## RockStar® Technical Information

Issue	<b>Addition to TI regarding re-design HD7</b>
-------	---

This is a short addition to the technical information from June 13<sup>th</sup> this year regarding the re-design of HD7 inserts. We have modified the coding of HD7 inserts according to IEC 61984 (6.5.3.) to meet the requirements.

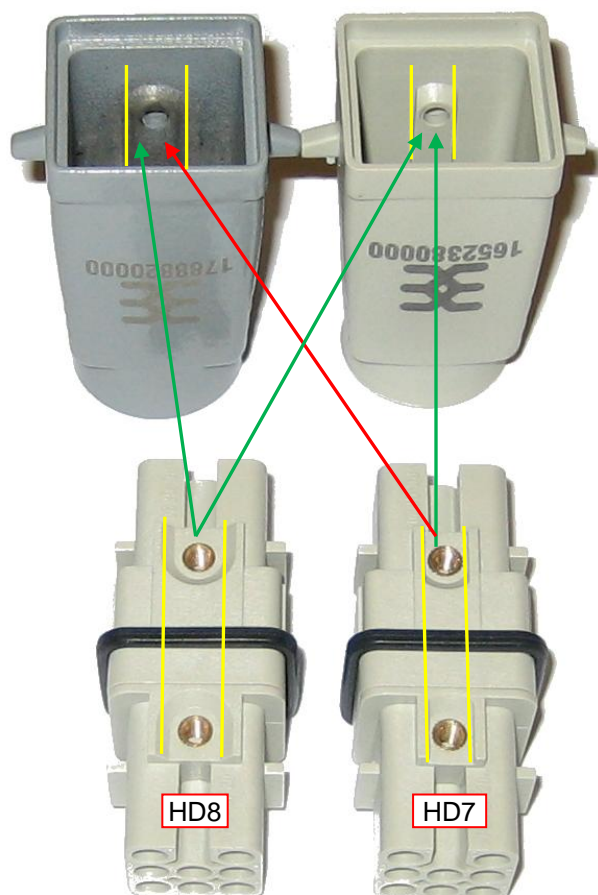
Accessible metal parts of a connector with an earthing contact which may become live in the event of an insulation fault shall be reliably connected to the earthing contact.

**Please note:** From now, the re-designed HD7 inserts (male/female) will only fit into plastic housings !

HDC HD 8	HDC HD 7
Plastic housing	<b>50 V</b>	<b>250 V</b>
Metal housing	<b>50 V</b>	<b>-</b>
